RE: **Volcano Cliffs Subdivision Lot 7 Block 8 Unit 18**  
**6509 Canavio Pl NW**  
**Grading and Drainage Plan**  
**Engineers Stamp Date 1/30/17 (D10D003O7)**

Based upon the information provided in your submittal received 1/17/17, the above referenced Grading and Drainage plan dated 1/17/17 cannot be approved for Grading Permit until the following comments are addressed:

**GRADING AND DRAINAGE PLAN**  
**LOT 7, BLOCK 8, UNIT 18, VCS**  
**ADDRESS: 6509 Canavio PL NW**

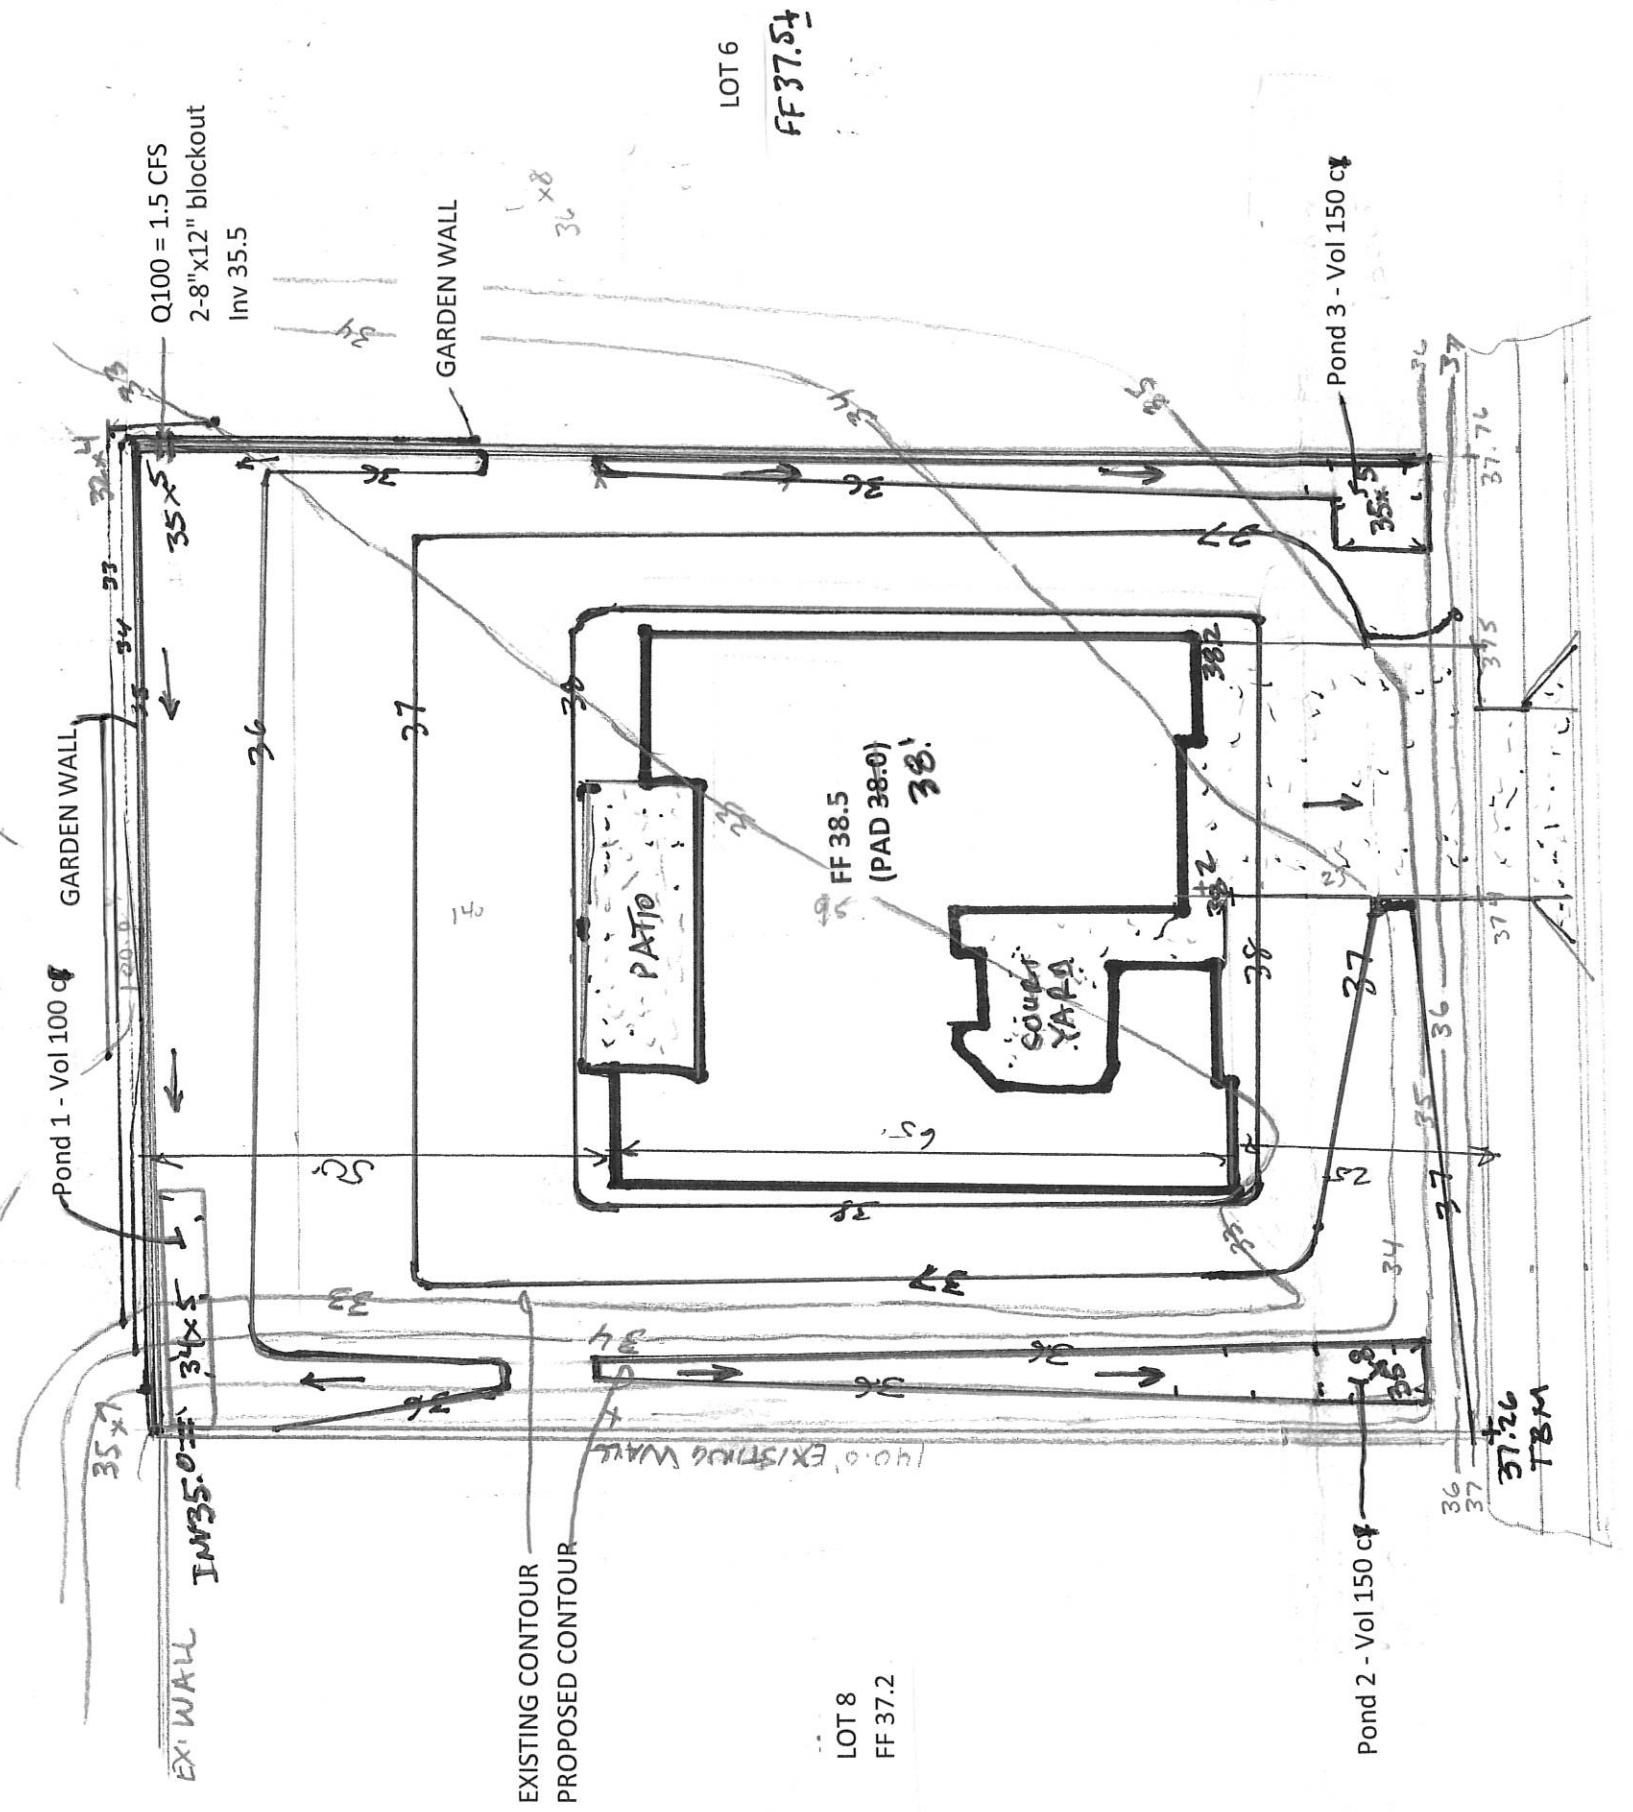
- Provide a note stating that future garden walls require a separate permit and this plan should be used for their placement.
- Provide a statement that a pad certification is required before a building permit is given.

1. Future garden walls will require a separate permit and this plan should be used for their placement.
2. A pad certification is required before a building permit will be provided by the City.

**GRADING AND DRAINAGE PLAN**  
**LOT 7, BLOCK 8, UNIT 18, VCS**  
**ADDRESS: 6509 Canavio PL NW**

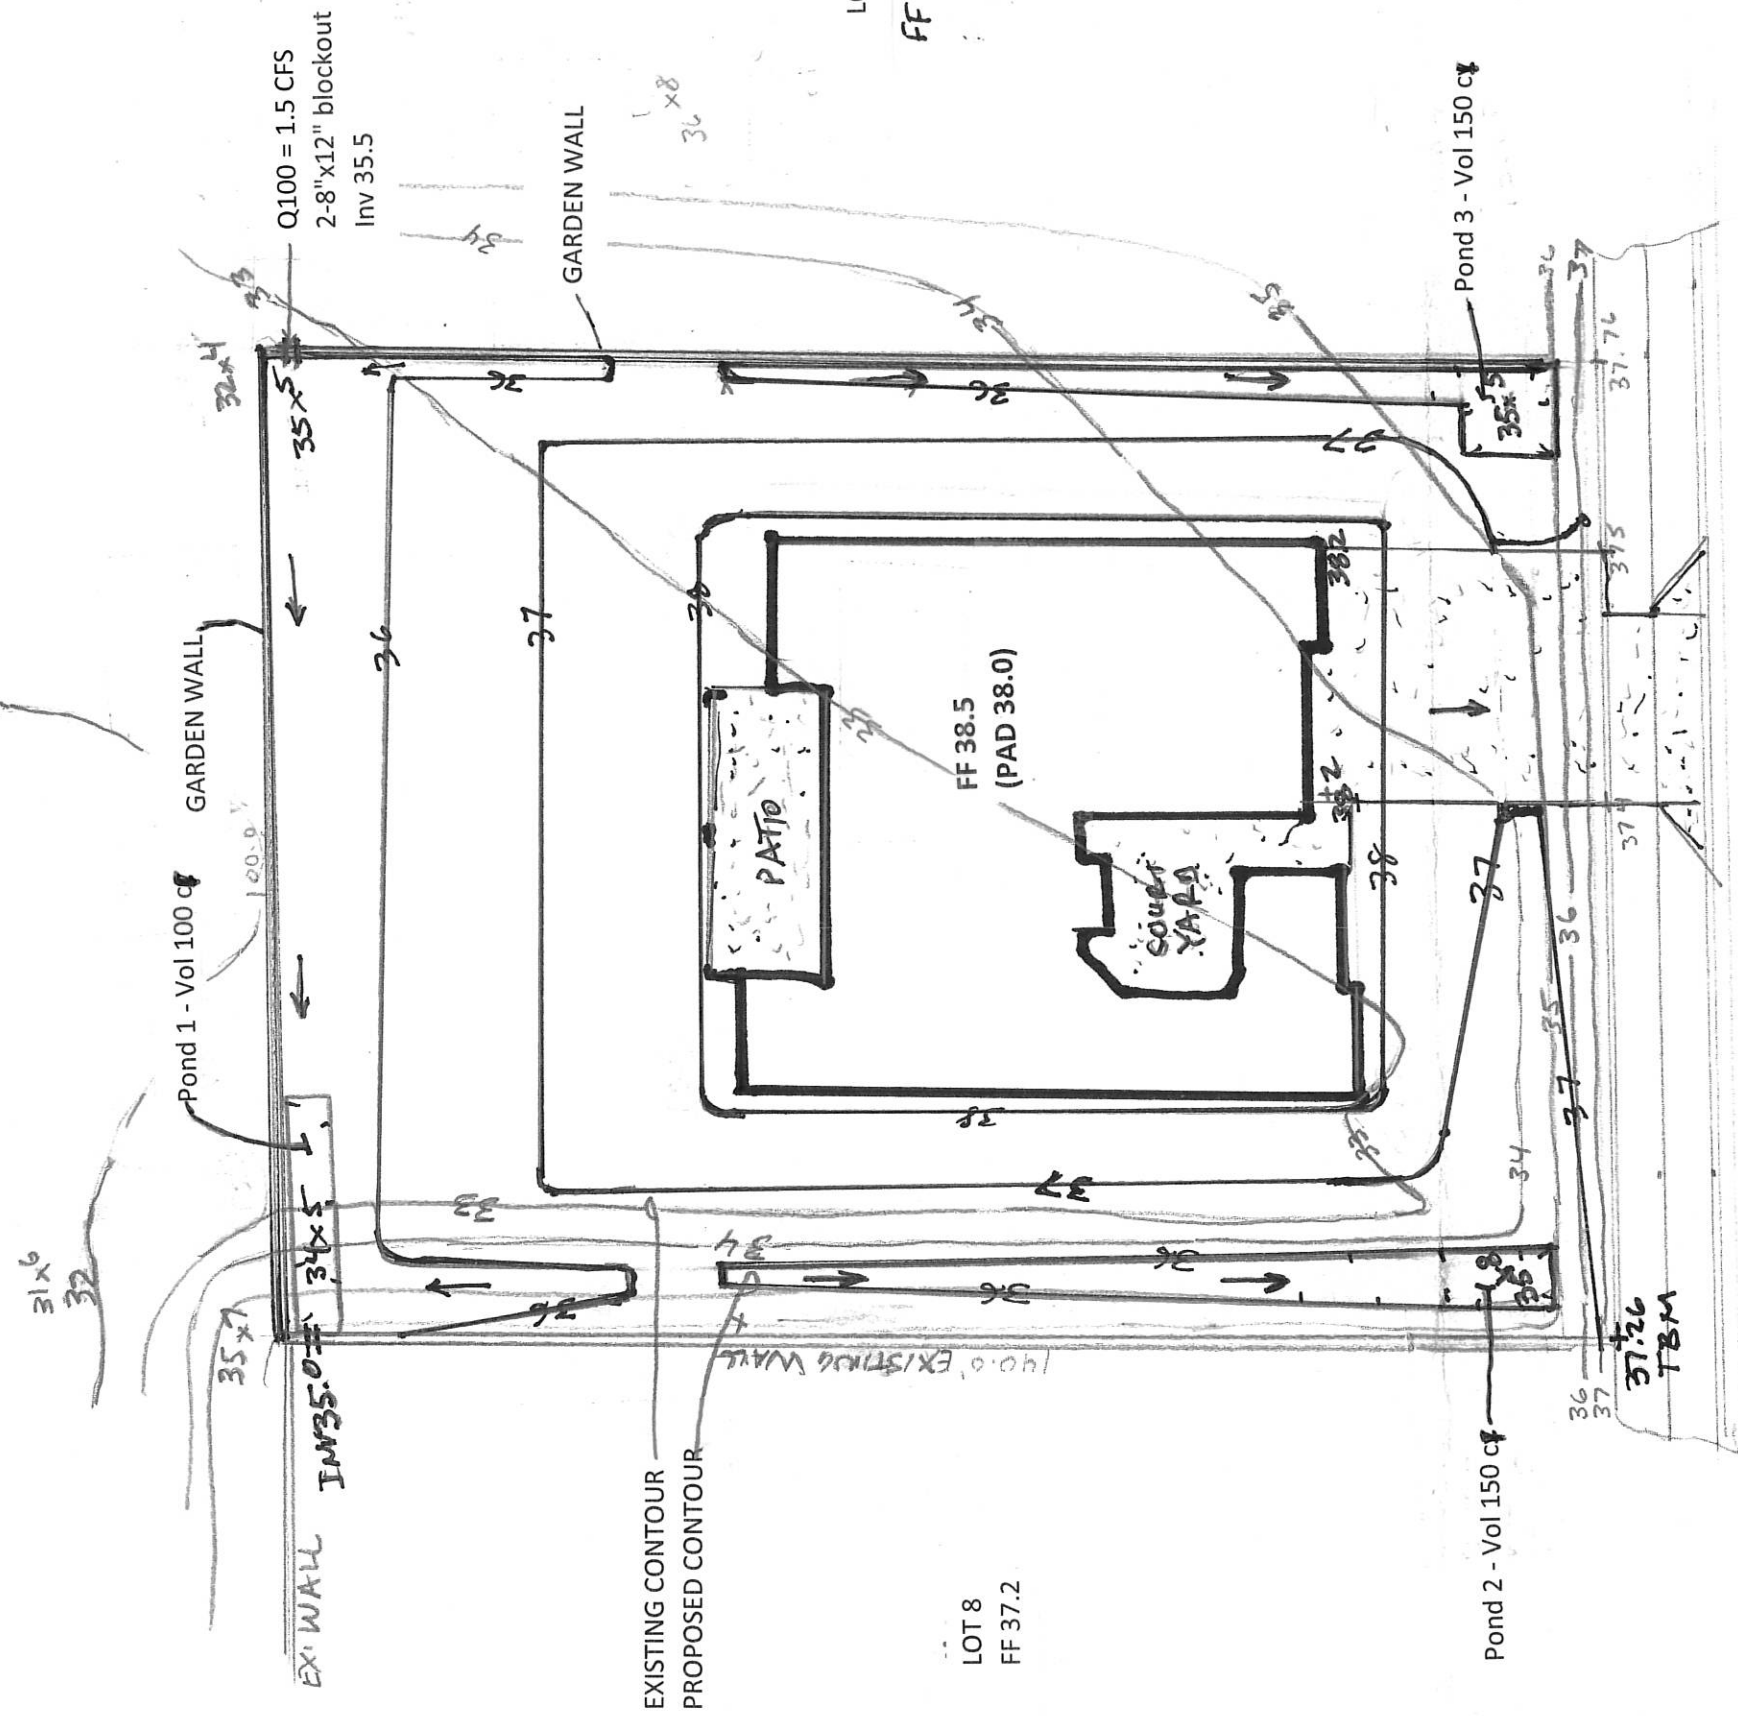
Based upon the information provided in your submittal received 1/17/17, the above referenced Grading and Drainage plan dated 1/17/17 cannot be approved for Grading Permit until the following comments are addressed:

- Provide a note stating that future garden walls require a separate permit and this plan should be used for their placement.
- Provide a statement that a pad certification is required before a building permit is given.
